RE: Review of Eklutna's Year 2 Study Plans

Enclosure: NMFS Comments on Eklutna Fish and Wildlife Program Year 2 Study Plans

NOAA Fisheries' Comments on Eklutna Fish and Wildlife Program Year 2 Study Plans

Figure 1: Peak stream flows before dam construction began (blue line).

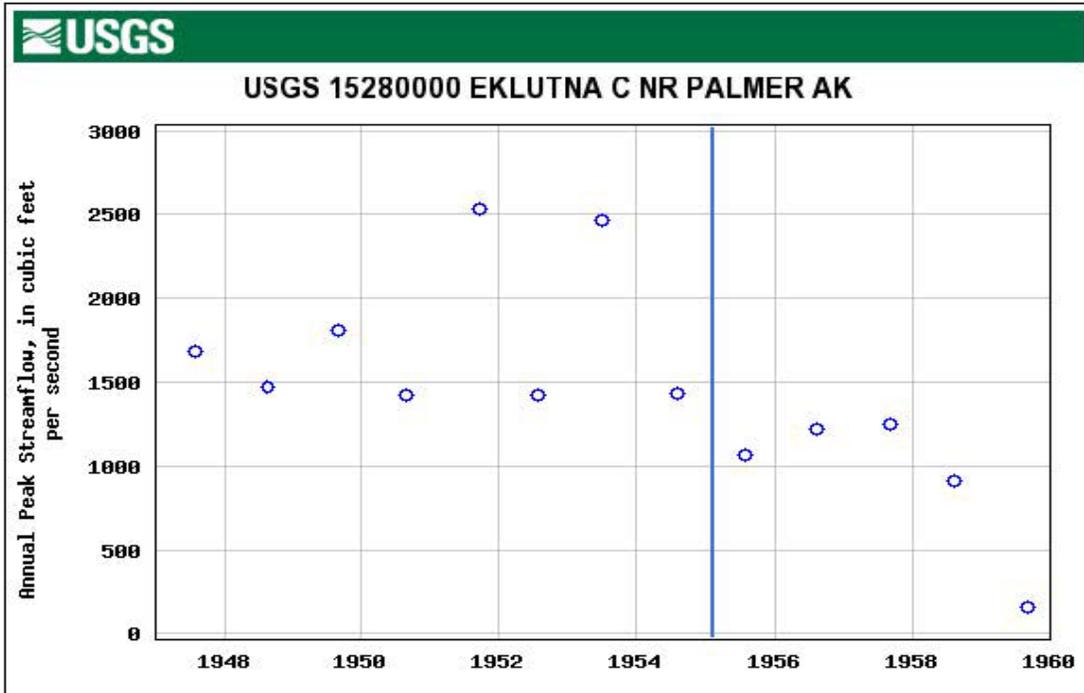
- IF-2 It has been nine years since the flow topped 450 cfs (August, 2013), and 27 years since the flow topped 1,000 cfs (9/25/1995) and over 70 years since Eklutna was a free flowing river at 2,550 cfs (1951). Prior to dam constructions, the Eklutna River regularly experienced annual peak flows above 1,400 cfs (Figure 1). Alluvial fans and vegetation have encroached on the Eklutna River channel and it is currently unaccustomed to historic natural flows. In the existing channel, there is very little appropriate spawning gravels for large bodied salmon, and there is no off-channel, slow-water habitat that holds water during the winter above the Thunderbird confluence. The HEC-RAS models being developed are not being applied to the channel that future salmon population will likely inhabit. In order to create suitable salmon habitat, the channel dimensions will likely need to change thereby invalidating the HEC-RAS flow model. Therefore, larger test flows are appropriate to inform the restoration planning process.
